**EL PASO WATER UTILITIES
PUBLIC SERVICE BOARD**

ADDENDUM NO. 2

**JOHN T. HICKERSON WRF
HEADWORKS BARSCREEN REPLACEMENT**

BID NO. 40-23

ELECTRICAL
MCC-10A
ONE-LINE DIAGRAM

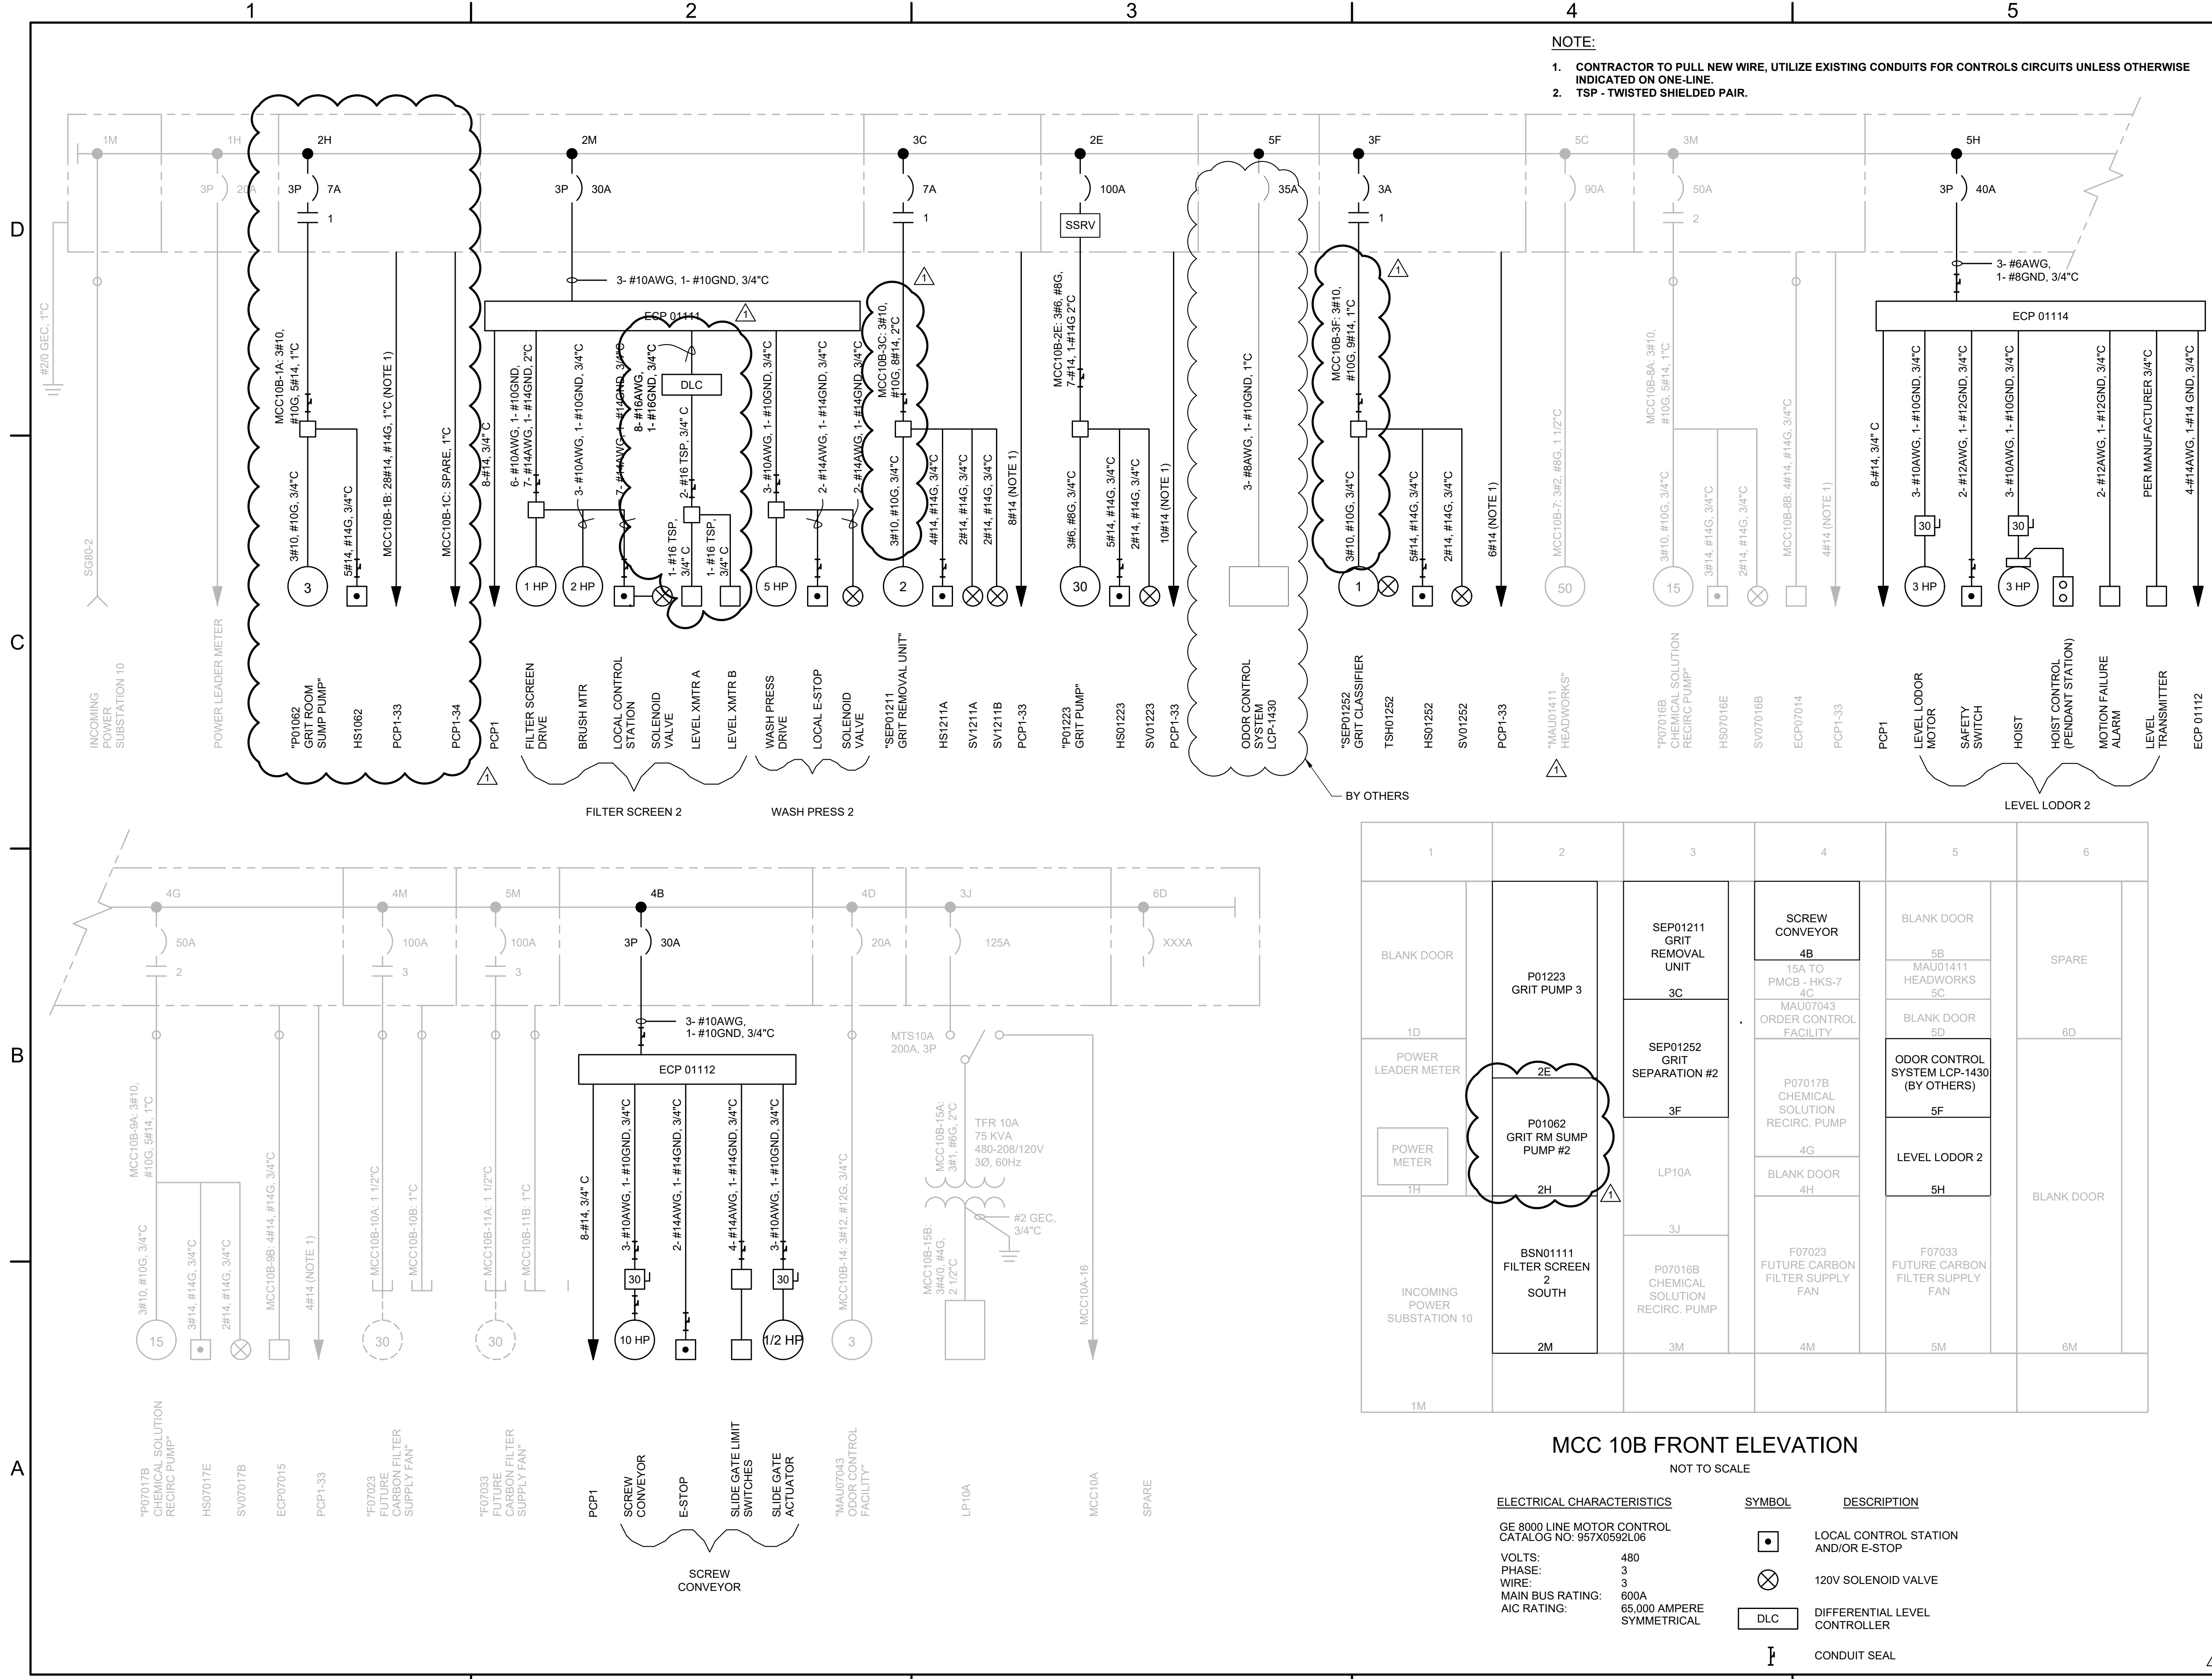
- AD-2.31. SHEET E013 - ELECTRICAL MCC-10A ONE-LINE DIAGRAM
- A. REMOVE Sheet E013 in its entirety and REPLACE with revised Sheet E013 attached to this Addendum. Changes reflect installation of Grit Room sump pump.

Q-2.06. Sheet E013, MCC-10A One-line Diagram, shows ECP 01101 and ECP 01113 to be added to control new pump motors and controls. Where are these control panels to be installed? Are these equipment control panels to include the starters for control of the associated motors? What is the composition of these equipment control panels as it relates to indicator lights and control stations?

A-2.06 Location of ECP 01101 and ECP 01113 are shown on Drawing E007. These ECPs include the starters for control of associated motors.
